Docket Item #4
BAR CASE# 2004-00240

BAR Meeting
November 10, 2004

ISSUE: Addition
APPLICANT: Janice Horst
LOCATION: 231 North West Street
ZONE: RB/Residential

Figure 1 - Proposed Rear Elevation

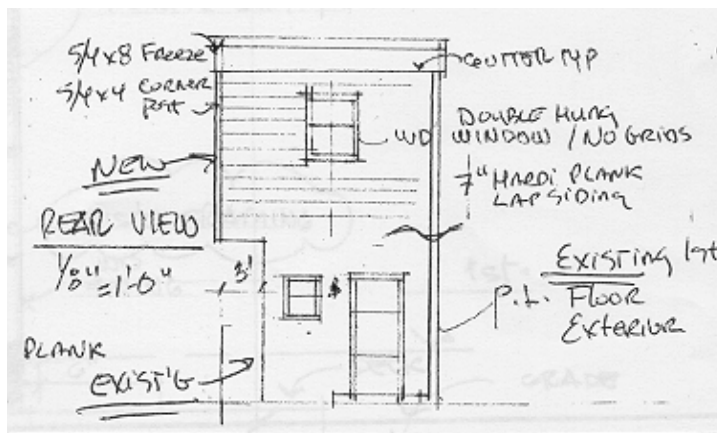
That the fiber cement siding be smooth (not wood grained) and that the nails not show in the installation.

In the opinion of staff, the modest addition complies with the design guidelines and is compatible with the simple frame house and its neighbors. The proposed addition will be very similar to that approved by the Board at 233 North West Street. Staff notes that the applicant proposes to use Hardiplank, a fiber cement siding. The Board has adopted the following policy with respect to the product.

The fiber cement siding is proposed for the new construction and thus is acceptable as long as it meets criteria #s 4 and 5.

That the fiber cement siding be smooth (not wood grained) and that the nails not show in the installation.
